Denial of Safety Credit for DOE's Use of "Drip  
Shields" in the Proposed Yucca Mountain Repository

**RE: Denial of Safety Credit for DOE's Use of "Drip Shields"  
In the Proposed Yucca Mountain Repository**

**SUMMARY OF CURRENT UNDERSTANDING OF  
DRIFT DEGRADATION AND ITS EFFECTS ON  
PERFORMANCE AT A POTENTIAL  
YUCCA MOUNTAIN REPOSITORY**

Drip  
Shield

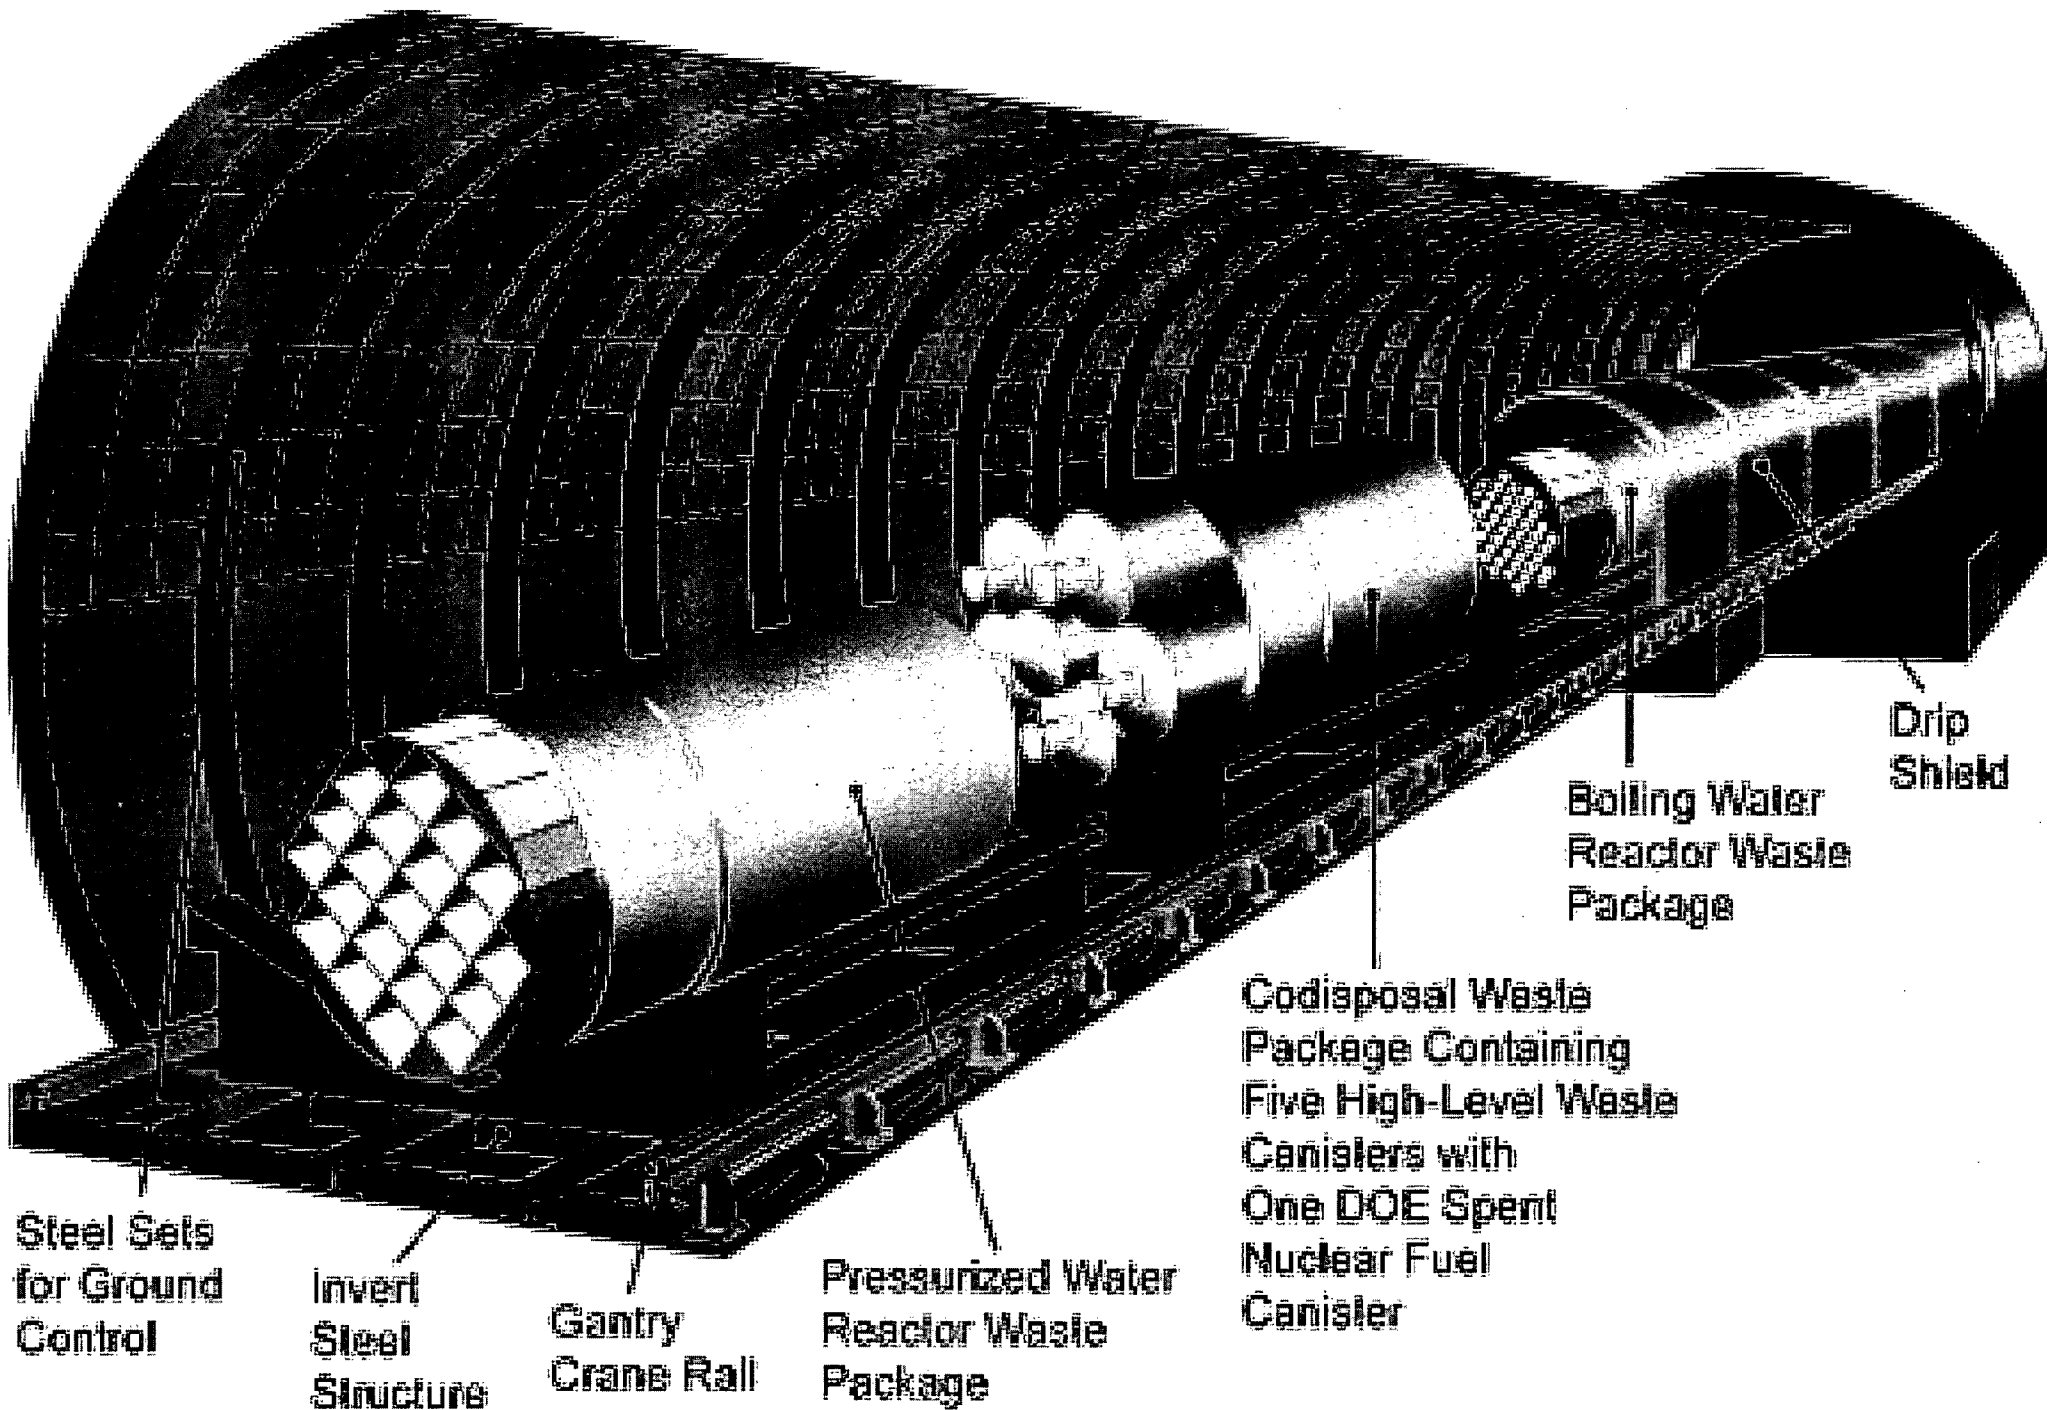
A fundamental problem with putting off drip shield installation for decades and perhaps centuries is that it is extremely unlikely that it will even be possible to install them at all. The effort would be unprecedented. Because of the high temperatures and extremely high radiation fields in the repository drifts, the drip shields would need to be installed remotely, using as-yet-nonexistent robotics. The drift environment will be heavily dust-laden, which will make remote visual monitoring of placement operations difficult if not impossible. It will be extremely difficult if not impossible to install the drip shields within the projected tight clearances in the drifts. Installation equipment will have to be brought by electric locomotives of a kind not yet in existence. The rails over which they would have to travel, and the rails supplying electric power, will almost certainly have corroded by the time they are needed. The installation equipment will need to be custom-designed to operate reliably in a dusty, hot, and radioactive environment, and will need a means for retrieval and repair of disabled equipment. DOE has recognized that there are so many uncertainties and potential difficulties with drip shield installation that "field tests to determine feasibility of operations *will be required*." See DEN 001480432 (emphasis added). It is doubtful, however, that realistic field tests can even be performed. DOE has even conceded that "human beings probably cannot reliably make a drip shield." See DEN001227105 (emphasis added). Additionally, anticipated rock-fall would likely by itself make installation of the connected drip shield structures physically impossible.

**Figure 4-2. Comparison of FracMan Synthetic Fracture Populations Based on Input From (a) DOE (Bechtel SAIC Company, LLC, 2004b, Figure 6-18, p. 6-34) and (b) CNWRA (Smart, et al., 2006)**

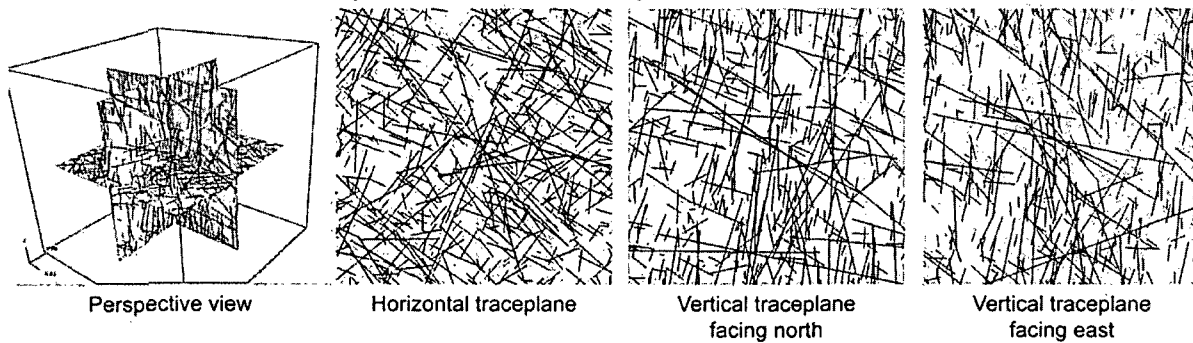
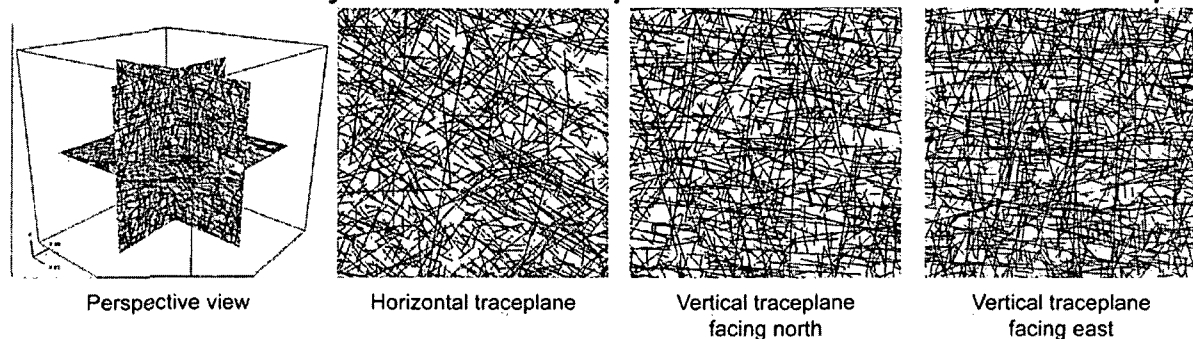
Staff have previously expressed concern (NRC, 2004; Virgilio, 2004) with the DOE representation of the Yucca Mountain fracture data in the FracMan analysis and indicated that a quantitative comparison of the DOE-generated FracMan synthetic fracture populations against the fracture data would be prudent. While the orientations of steeply dipping fractures in the synthetic population are similar to the natural fracture data, the shallowly dipping fracture set is underrepresented in the DOE synthetic population (Smart, et al., 2006). The DOE synthetic population also contains a concentration of moderately northeast-dipping fractures (Bechtel SAIC Company, LLC, 2004b, Figure 6-19, p. 6-38) that are not observed in the natural fracture population (Smart, et al., 2006, Figure 3-7, p. 3-17).

The DOE assertion that the nonlithophysal rock is dominated by nonpersistent fractures does not appear to be supported by the available fracture data. An independent review of the data (NRC, 2004, p. 18) suggests that the majority of the large scale fractures {i.e., trace lengths >1 m [3.3 ft]} abut or cut across other fractures on at least one end where visible (i.e., not obscured by engineered supports). The argument for nonpersistent fractures in the nonlithophysal rocks is further weakened if small scale fractures {i.e., trace lengths <1 m [3.3 ft]} are considered, because these may link larger fractures, thus increasing overall connectivity. Consequently, excessive use of rock bridges in the 3DEC analyses appears to have produced a

rock-mass model with fewer kinematically removable blocks than may be realistic for the nonlithophysal rock at Yucca Mountain. The DOE analysis would have resulted in greater rockfall volumes and larger changes in emplacement-drift geometry if a more accurate representation of fracture connectivity had been used.

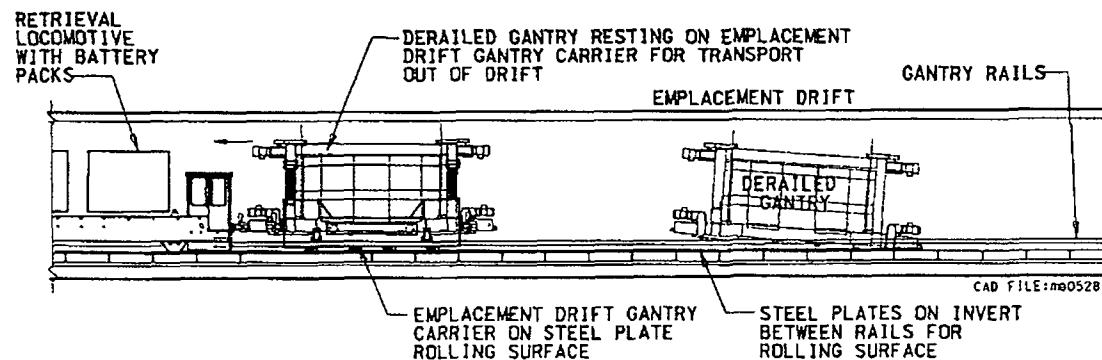
- From zero to as much as 300 years after emplacement
- 50°C (122°F) or higher temperature environment
- Radioactive environment
- Ventilated at overall 15m<sup>3</sup>/second airflow which will carry dust
- Tight clearances
- Very dusty environment
- Likely corroded steel or copper electric third rail
- Likely corroded mild steel railroad rails

If emplacement gantry derails, it will damage and dig-into side walls of drift, severely complicating recovery

# Large Ground Collapse in Emplacement Drift with Ventilation Airflow Unaffected

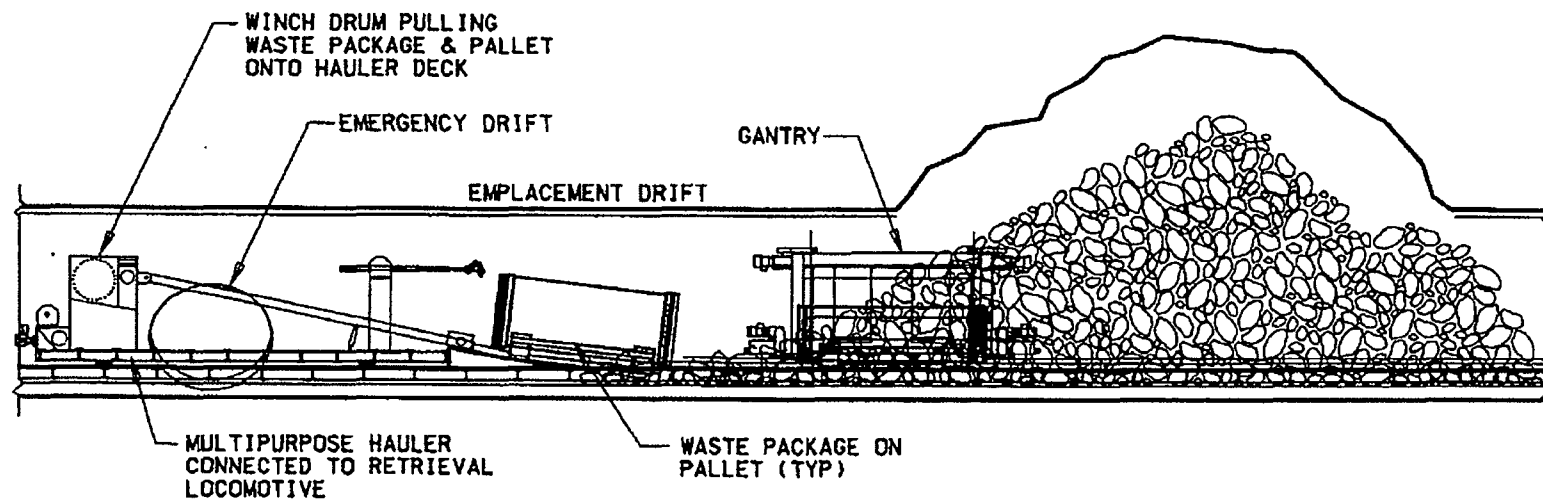
Usually-depicted major ground failure situation in tuff

# Large Ground Collapse in Emplacement Drift with Ventilation Airflow Blocked

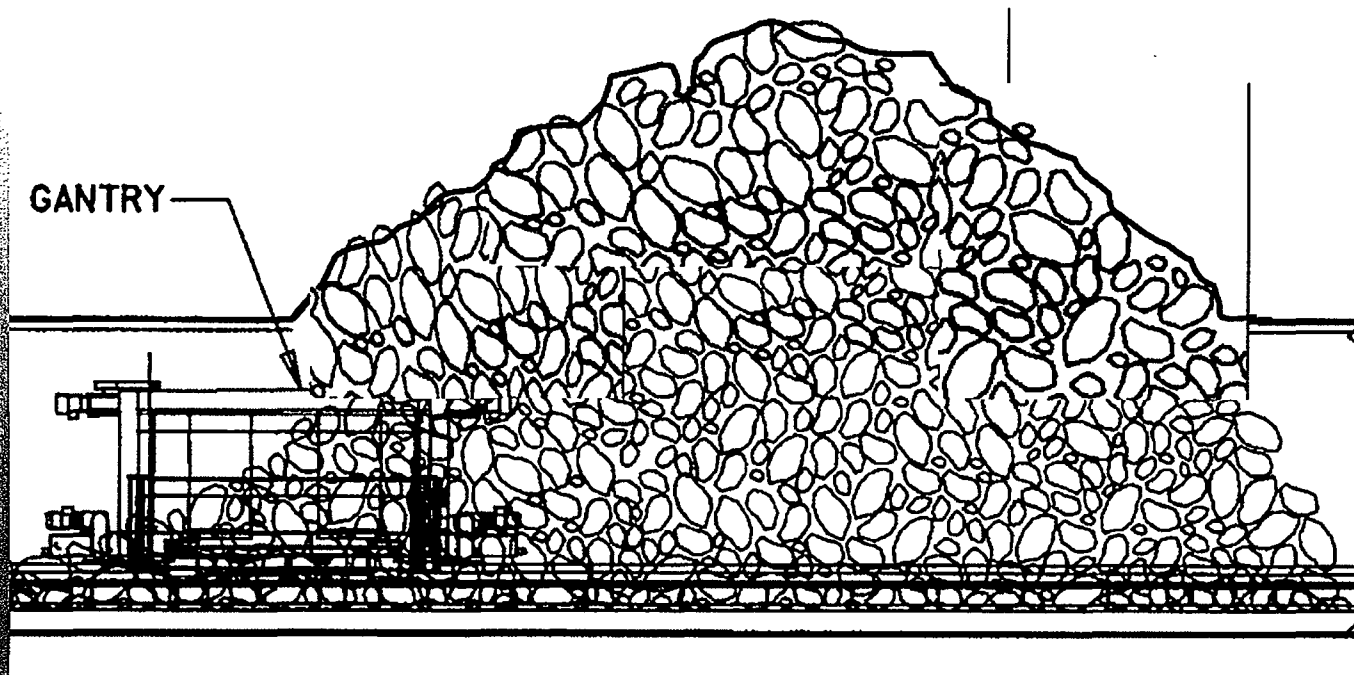
Most likely major ground failure situation in tuff

# **Large Ground Collapse in Emplacement Drift with Ventilation Airflow Blocked**

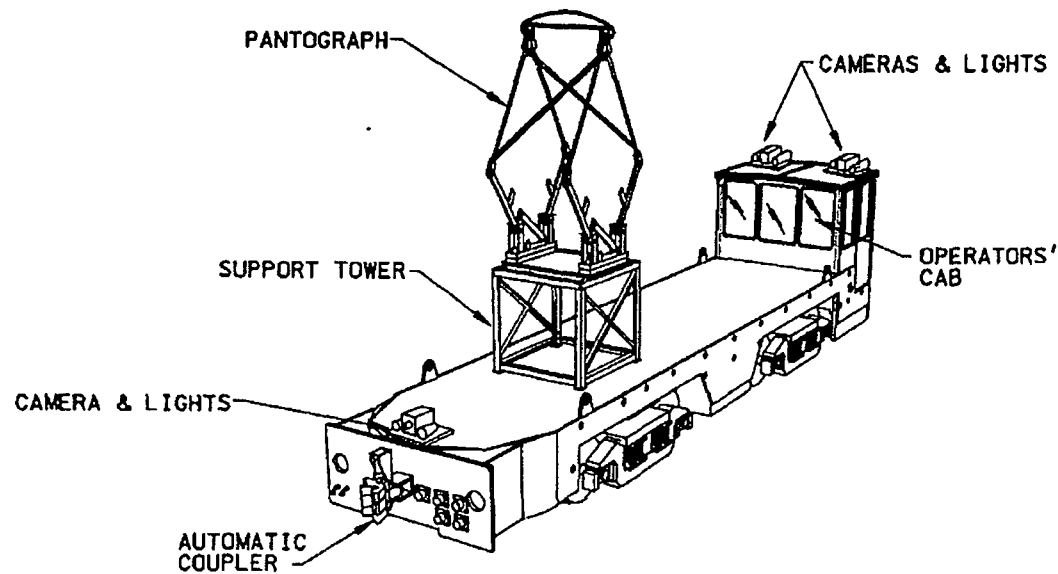
- Buried waste packages
- Blocked airflow
- Heat not dissipating
- Dangerous radioactive environment
- Rising temperatures
- Tunneling in from adjacent drift or raise boring up from ventilation level will be slow and difficult

# Mining Locomotives

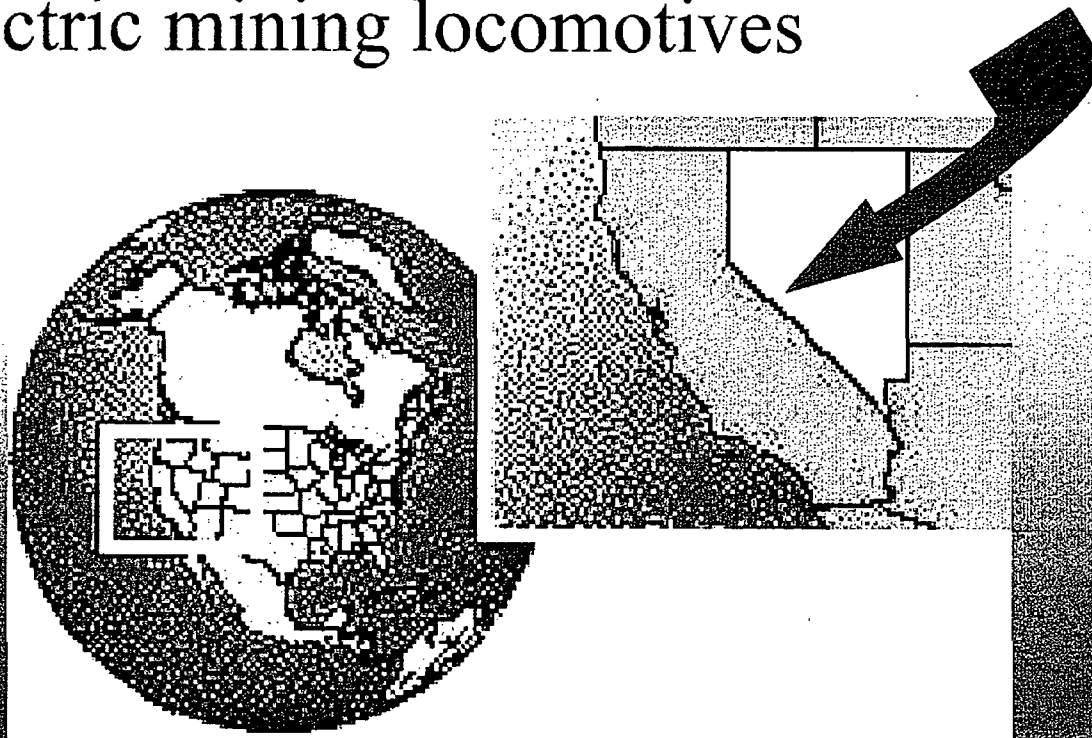
Yucca Mountain Project is quite likely the last remaining United States market for large electric mining locomotives

# Common Problems

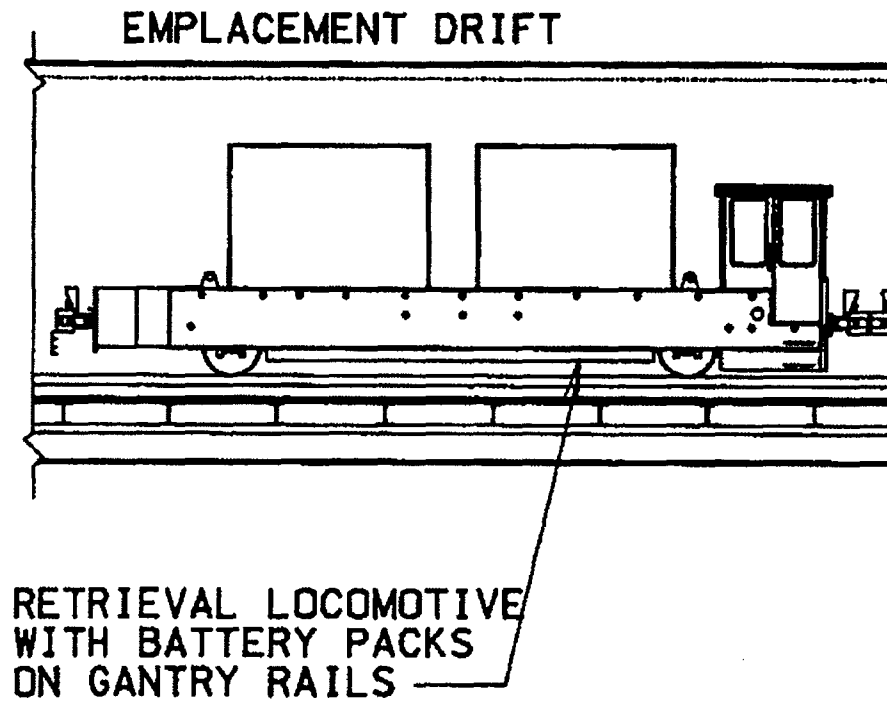
- 750-V wet cell batteries do not exist
- Above ~300-V cell-to-cell arcing and creep occur
- 750-V locomotive will operate at 300-V but slower with less power
- Wet cell battery discharge increases rapidly above 60°C (140°F) due to  $\text{Pb} \rightarrow \text{PbO}_2$  reaction in acid
